## MEMORANDUM

**SUBJECT:** Setdown Report: Zoning Commission Case No. 08-34(A) for Second-Stage Approval of a Commercial Building in the South Block (Capitol Crossing)

Exhibit 4: Proposed Plan for the South Block site, looking across 3<sup>rd</sup> Street NW.

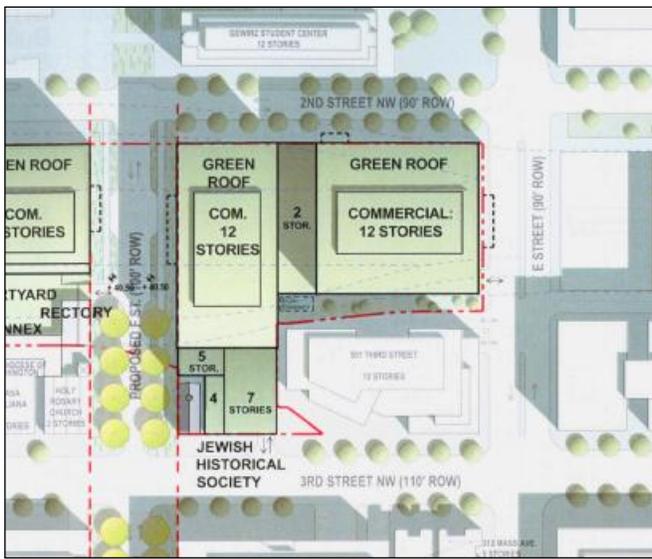
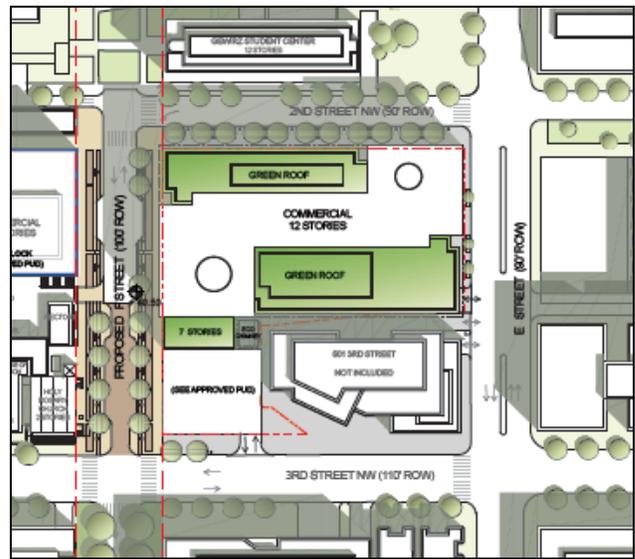
The building form would be reshaped from earlier conceptual designs approved in Order No. 08-34 (as shown in Exhibit 3 and 4 above). It now would be "organized into two parallel bars with a full-height glass atrium in the center."<sup>6</sup> The massing would be concentrated along 2<sup>nd</sup> and F Streets, with a step down to seven-stories on the building's west side. Entrances on E, F, and 2<sup>nd</sup> Streets would be recessed from the main street façade to further articulate the building frontages. A consequence of the massing changes is a slight increase in lot occupancy to about 92%, which exceeds the 90% lot occupancy anticipated in previously approved drawings. The building would set back from the E Street Property line by 6'10", accommodating a width of 14' between the curb and ground floor façade.<sup>7</sup> Retail spaces would line the ground floor along adjacent streets. The Applicant has indicated to OP that retail ceiling heights would be
